CAPRICORN MUNICIPAL DEVELOPMENT GUIDELINES

2022 MEETING 09 MINUTES

Date and Time: 7 October 2022 11:00 am

D05.18. PIPE MATERIAL

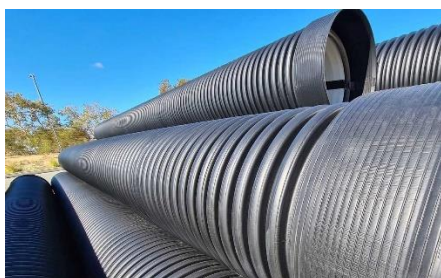
6-2021	CMDG-D, CMDG-D5, C221.		Addition of corrugated polypropylene drainage pipes.	<p>Twin wall corrugated polypropylene drainage pipes offer many benefits compared to reinforced concrete pipes. Benefits include:</p> <ul style="list-style-type: none"> • Excellent corrosion and chemical resistance • Can be cut to length with no detriment to corrosion resistance • Excellent rubber ring joint sealing system • Smooth bore providing optimum hydraulic performance • Available in 6 metre lengths • Lighter to handle with a lower risk rating for those handling the pipes • Smaller diameter pipes can be manually handled • Lower transport costs • Large and diverse range of fitting available <p>1.1 CMDG-D, CMDG-D5, C221. Addition of corrugated polypropylene drainage pipes.</p>
--------	------------------------	--	--	---

- C221 Section C221.04 mentions FRC and RCP pipes but not Plastic.
- Current Section D05.18 reads as follows.

- It is noted that Hydra Storm supplies pipe as follows:
 - Manufactured in accordance to AS – NZS 5065
 - Available from Diameter Nominal (DN) 225mm to 600mm
 - Manufactured from recycled HDPE

- C221 will need to be updated at the same time as D5.
- Richard mentioned that he is meeting with a representative from Iplex next week where he will get additional information and specifications.

- Richard has met with the sales Rep but proposed changes to D5 and C221 are still being considered. It is recommended that Polypropylene pipes with classification SN8 are approved up to a diameter of 600mm.
- The technical guide for Blackmax (Iplex) is included as ~~Attachment N~~.

Richard to collate information and specifications and send to committee for further discussion at next meeting with proposed changes to D5 and C221 to permit use of corrugated polypropylene drainage pipes.
